LONDONDERRY, NH PLANNING BOARD

MINUTES OF THE MEETING OF OCTOBER 5, 2016 AT THE MOOSE HILL COUNCIL CHAMBERS

MEMORANDUM

Re: Map 12 Lot 5
Subdivision Plan
Alexander & Litchfield Roads

BOUNDARY PLAN

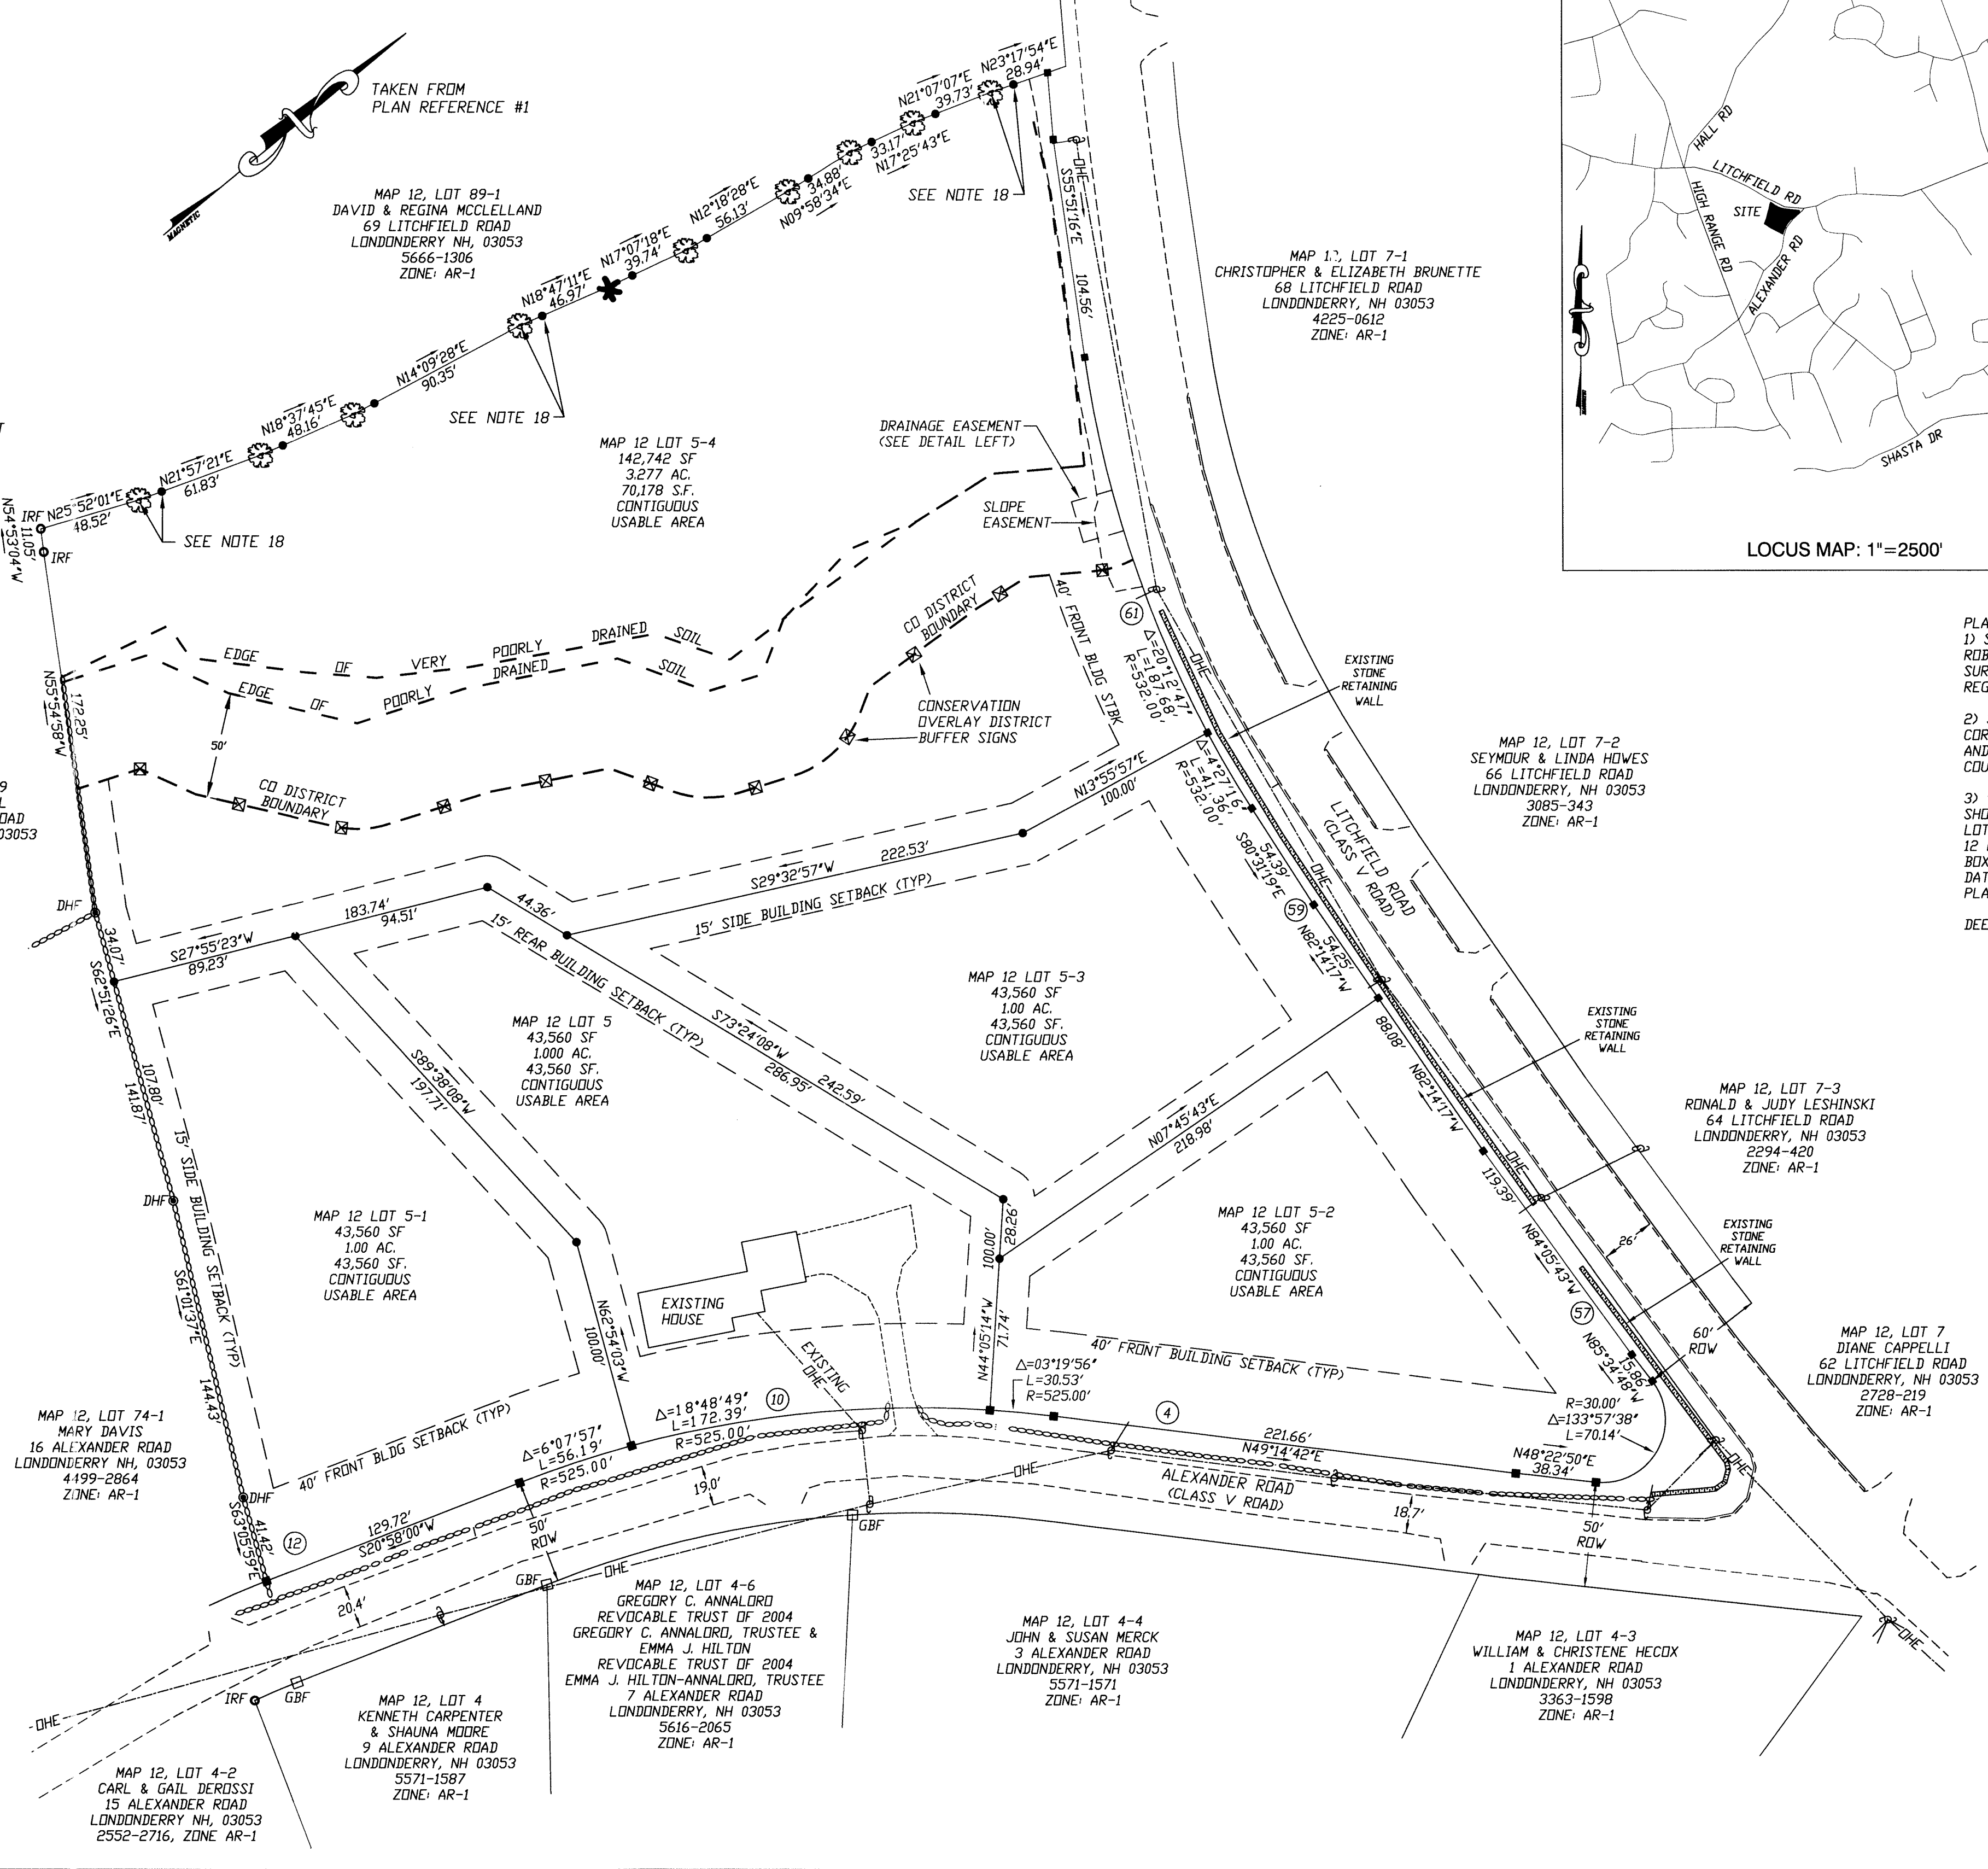
1. The Applicant's plan does not provide topography on the western portion of Lot 5-4 as required by Item VI.24 of the checklist. The submission does include sufficient HISS-mapped area on lot 5-4 to substantiate a single lot. The Applicant has submitted a **waiver request** for this requirement per section 3.10 of the regulations.

1. The Applicant is requesting a waiver to Item VI.24 of the Subdivision Application Checklist requiring topography be shown over all subject parcels. The plan does not provide topography over the western portion of the proposed Lot 5-4. Staff recommends **granting** the waiver as the Applicant has provided sufficient HISS mapping per Section 3.10 of the regulations to substantiate a single lot.
